**SAFETY RECALL NOTICE**

**UPPER STEERING SHAFT COUPLING BOLT**

**TO: ALL LAMBORGHINI DEALERS**  
**FROM: Lamborghini Technical Services**  
**SUBJECT: LAMBORGHINI SAFETY RECALL CAMPAIGN N° 03V-375**  
**( L147.R-01.03US)**  
**DATE: 10/XX/03**  
**VEHICLE: 2002 - 2003 LAMBORGHINI MURCIÉLAGO – UPPER STEERING**  
**SHAFT COUPLING BOLT**

**RECALL CAMPAIGN NO. 03V-375 (L147.R-01.03US)**

Fig. 1

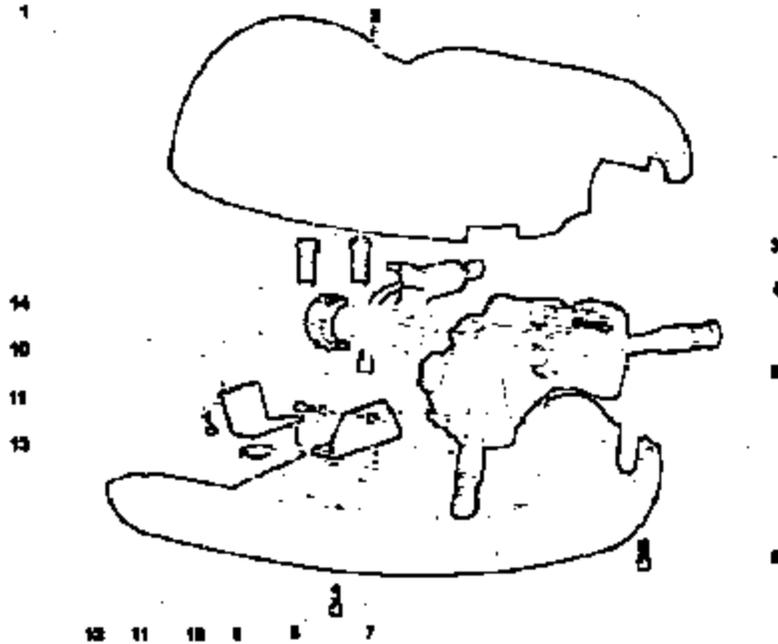
- 1.1 Remove the lower cover (13) removing the attaching screws (6) and (8) referring to Figure 1.
